4 March 2019

SSD 8596 – MOD 1 – SECTION 4.55(1A) MODIFICATION APPLICATION WESTERN BUILDING, UNIVERSITY OF WOLLONGONG

Figure 1 Approved northern façade (above) and proposed (below)

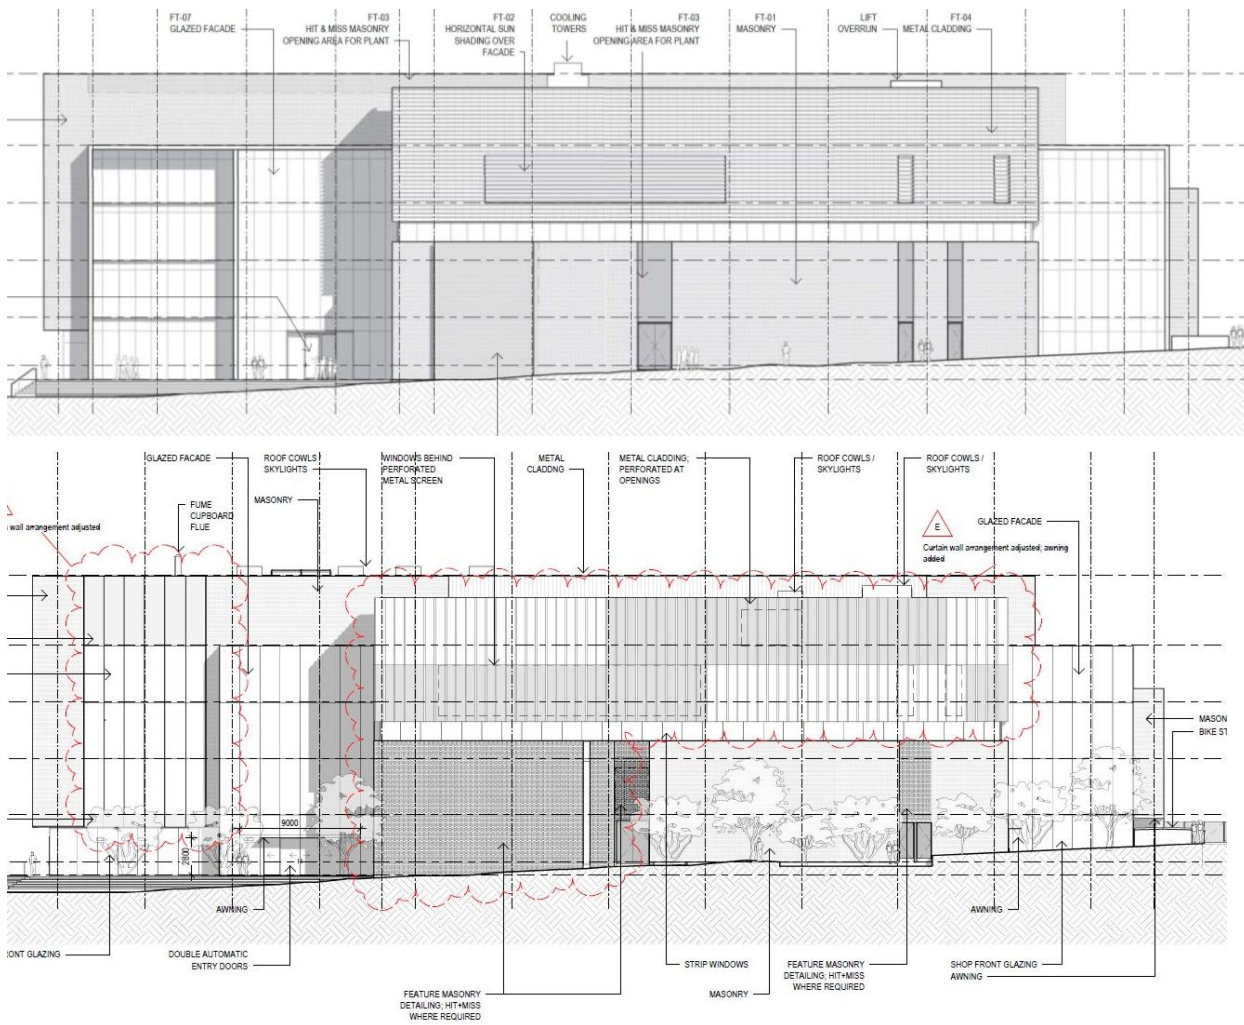
Notable changes include the further rationalisation of the facades to achieve a more vertical expression, which is attained through the inclusion of vertical fins located at intervals between masonry brickwork. At street level, feature masonry has been included adjacent to the entrances for the purpose of achieving a more varied materiality that provides greater visual interest. Further, the amended design has sought to further refine the façade at ground level by incorporating a vertical and horizontal aluminium and glazed façade system that improves the articulation of the building.

Level / Location	Description of Proposed Modification	Drawing No.	Revision.
Eastern Elevation	<ul style="list-style-type: none"> horizontal metal cladding to be deleted and replaced with vertical metal cladding/fins; inclusion of a steel framed awning 2.8m in height and 2m in length; deletion of the cooling towers; and addition of aluminium framed glazing. 	SK_0043	F
Northern Elevation	<ul style="list-style-type: none"> inclusion of roof cowls/skylights; inclusion of an awning above the entrance doors with a length of 9m and a height of 2.8m; introduction of feature masonry detailing at street level adjacent to the entrances; deletion of the horizontal sun shading to allow for their replacement with vertical perforated metal screening; reduction in the extent of the masonry to facilitate the inclusion of additional glazing and metal curtain walling; and inclusion of additional roof plant comprising a fume cupboard flue. 	SK_0042	F

Figure 2 Approved southern façade (above) and proposed (below)

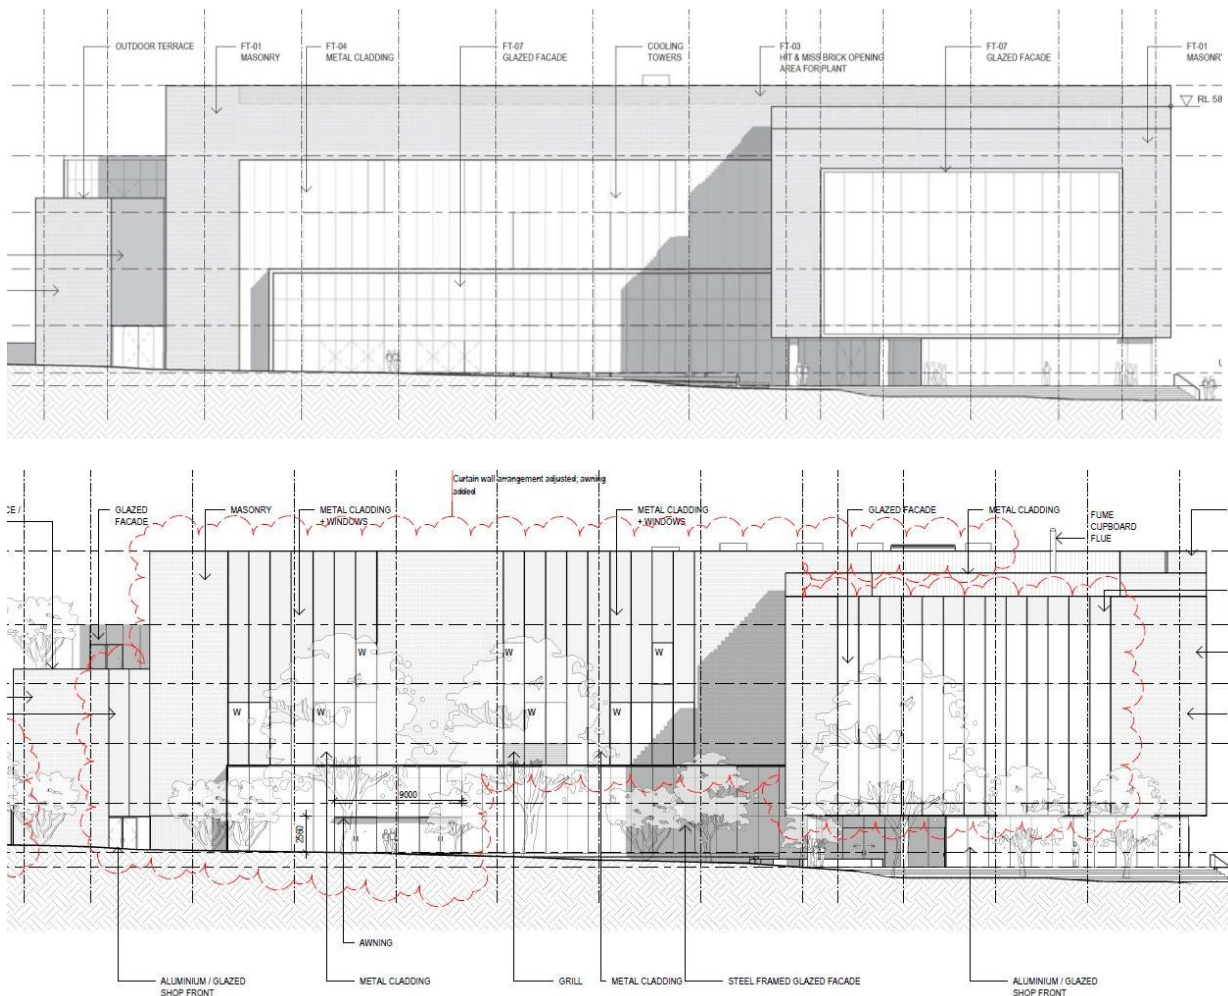
Western Elevation	<ul style="list-style-type: none"> amendments to the plant at roof level, including the addition of a fume cupboard flue and removal of the cooling towers; removal of the horizontal sun shading to accommodate the introduction of vertical metal cladding with perforated openings and glazing; and minor reduction to the building height from RL 59.30 to RL 58.70. 	SK_0043	F
Southern Elevation	<ul style="list-style-type: none"> inclusion of metal cladding and glazing with a vertical expression; addition of a steel framed glazed façade at street level; and inclusion of a fume cupboard flue. 	SK_0042	F

Figure 3 Proposed location of the external bin store

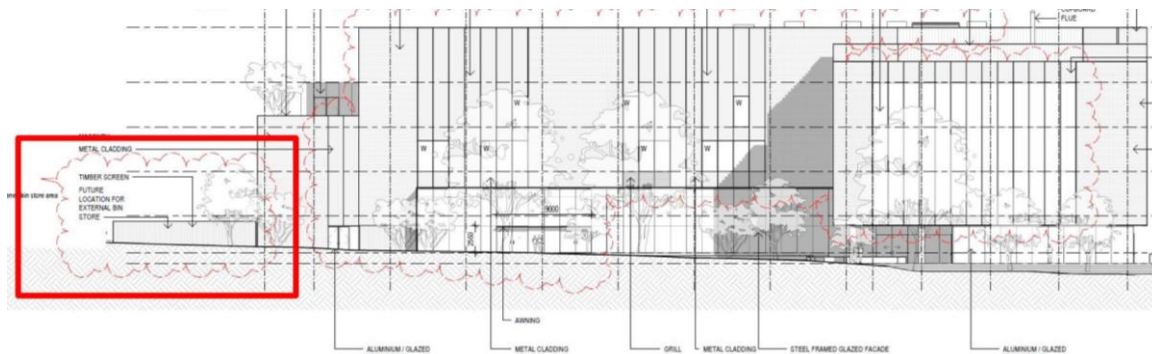
The proposal seeks to finalise the location and design of the plant/bin storage area which is proposed to be located to the west of the approved building and adjacent to the loading dock (refer to **Figure 3**). As noted in the EIS and supporting documentation, a waste storage area was always intended to be located adjacent to the vehicular entrance point for the Western Building.

The proposed modification includes further details pertaining to this waste storage area and demonstrates that it will be of high quality design and screened with timber panelling (refer to **Attachment A**). In addition to accommodating a bin store, the storage area will contain an emergency generator. Access to the storage area will be restricted to authorised personnel.
